WELL API NO. 30-025-29130
5. Indicate Type of Lease STATE <input checked="" type="checkbox"/> FEE <input type="checkbox"/>
6. State Oil & Gas Lease No. 19520
7. Lease Name or Unit Agreement Name North Hobbs G/SA Unit
8. Well Number 312
9. OGRID Number 157984
10. Pool name or Wildcat HOBBS; GRAYBURG-SAN ANDRES
11. Elevation (Show whether DR, RKB, RT, GR, etc.) 3683' GL

SUNDRY NOTICES AND REPORTS ON WELLS
(DO NOT USE THIS FORM FOR PROPOSALS TO DRILL OR TO DEEPEN OR PLUG BACK TO A DIFFERENT RESERVOIR. USE "APPLICATION FOR PERMIT" (FORM C-101) FOR SUCH PROPOSALS.)

Objectives: Rig up on well to address identify and eliminate source of current high casing pressure.

Operator: OCCIDENTAL PERMIAN LTD P.O. Box 4294 Houston, TX 772104294	OGRID: 157984
	Action Number: 439904
	Action Type: [C-103] NOI Workover (C-103G)

Proposed WBD

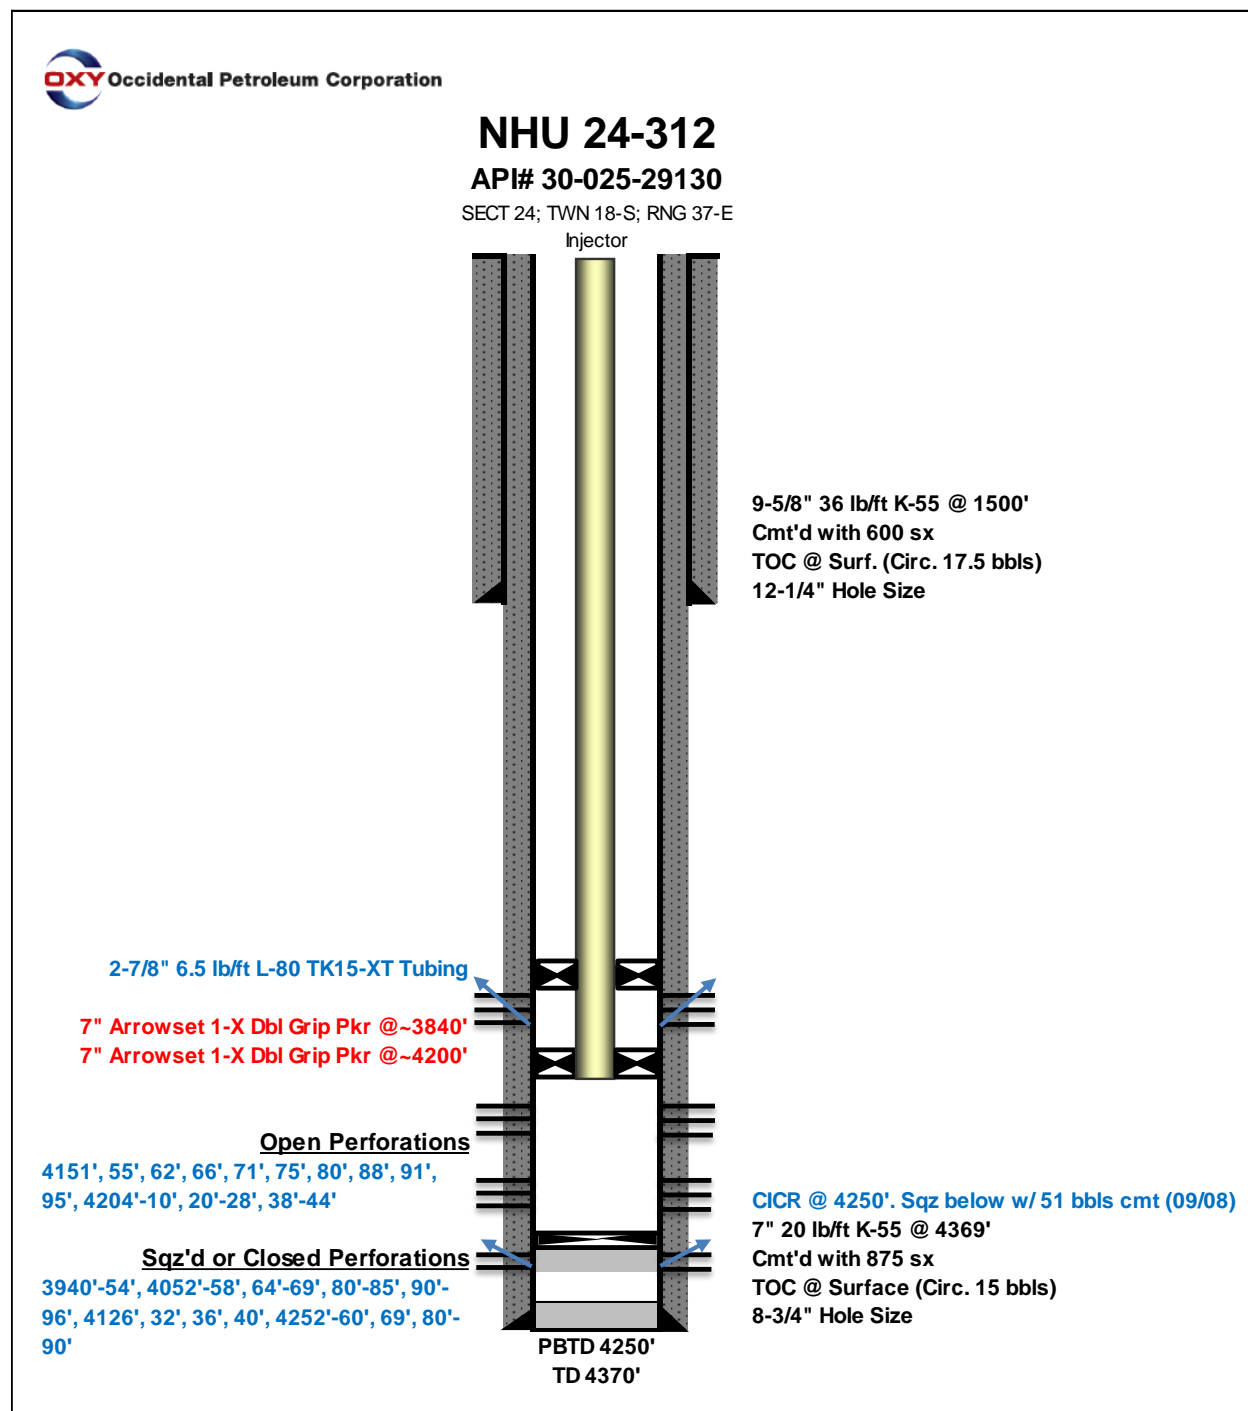
Created By	Condition	Condition Date
mgebremichael	If the workover requires changing the tube, replace it with the same tube size as stipulated by the respective order. The packer shall not be set more than 100 ft above the top part of the injection interval. And, ensure that the built-up pressure source is determined and a Bradenhead test is conducted to ensure the pressure is not building up again.	4/24/2025
